Secretary
Department of Planning, Industry and Environment
320 Pitt Street
SYDNEY
NSW 2001

Sites 2A and 2B Australia Avenue, Sydney Olympic Park (SSD-9383)

I refer to your request for comments on SSD-9383 for the development of Sites 2A and 2B, Australia Avenue, Sydney Olympic Park (the site).

Figure 2

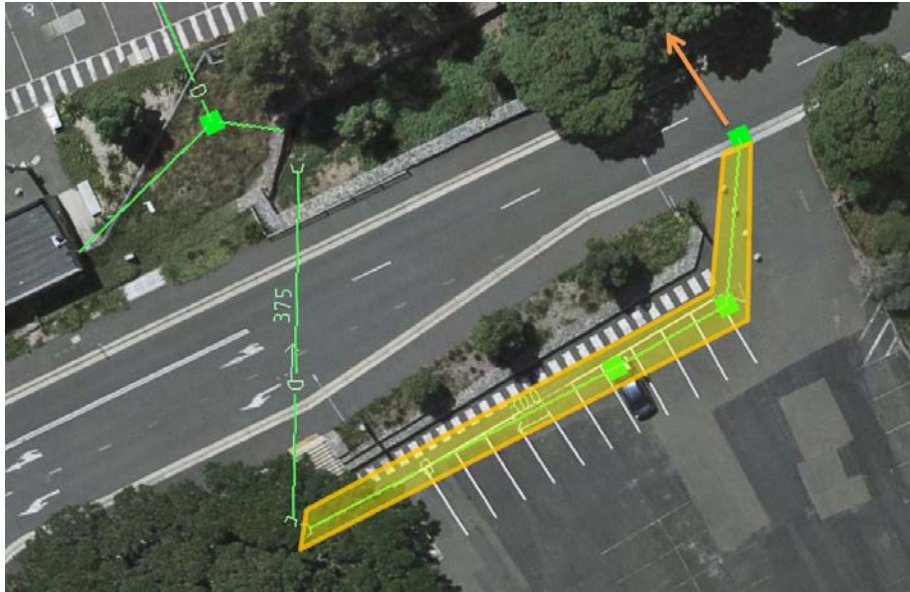
With regard to stormwater drainage, the pipe shown in the image below (Figure 2) must be made redundant and the street inlet pit be directly connected to the bio-swale on the opposite side of the road with a new pipe and headwall (the orange arrow). This change will have significant impact on the fig tree's water intake. Therefore, irrigation should be considered for the fig tree.

Further, the surface run-off from Dawn Fraser Avenue east must be drained to the tree pits with erosion measures for erosion prevention.
